**SUBMISSION: Endeavour Energy 2015-19 Price Proposal**

This submission has been prepared by Trans Tasman Energy Group (TTEG)<sup>1</sup> on behalf of Camden council (**Camden**) in response to public lighting aspects of Endeavour Energy's (**Endeavour**) price proposal.

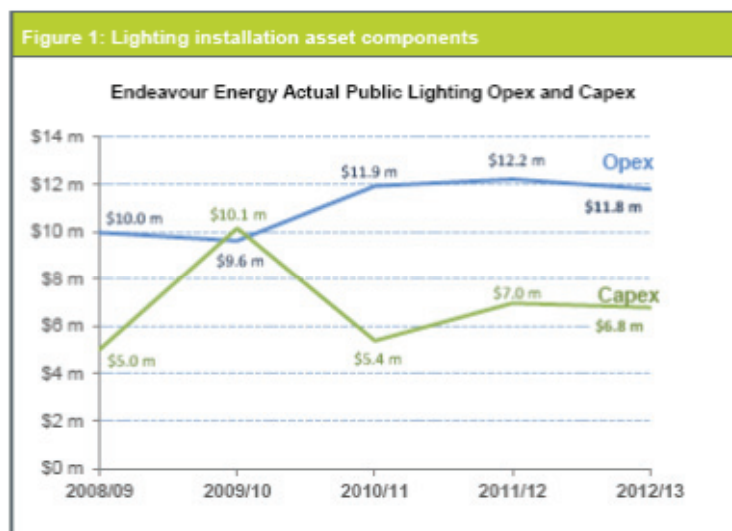
Endeavour Energy included the following figure in its Public Lighting Proposal<sup>6</sup> noting that the Opex includes overheads.

From the figure we note that Endeavour's 2012/13 Opex and Capex total is \$18.6 million.

The claimed \$6.8 million Capex component is of concern as fails to reconcile with the \$5.55 million of public lighting Capex in 2011/12 that Endeavour Energy identified in its Cost Allocation Method (CAM)<sup>7</sup>.

Of interest we note that the \$5.55 million for 2011/12 is close to the \$5.86 million contained in Endeavour's 2012/13 RIN.

We submit that the AER should require Endeavour to confirm its 2011/12 actual Capex cost.
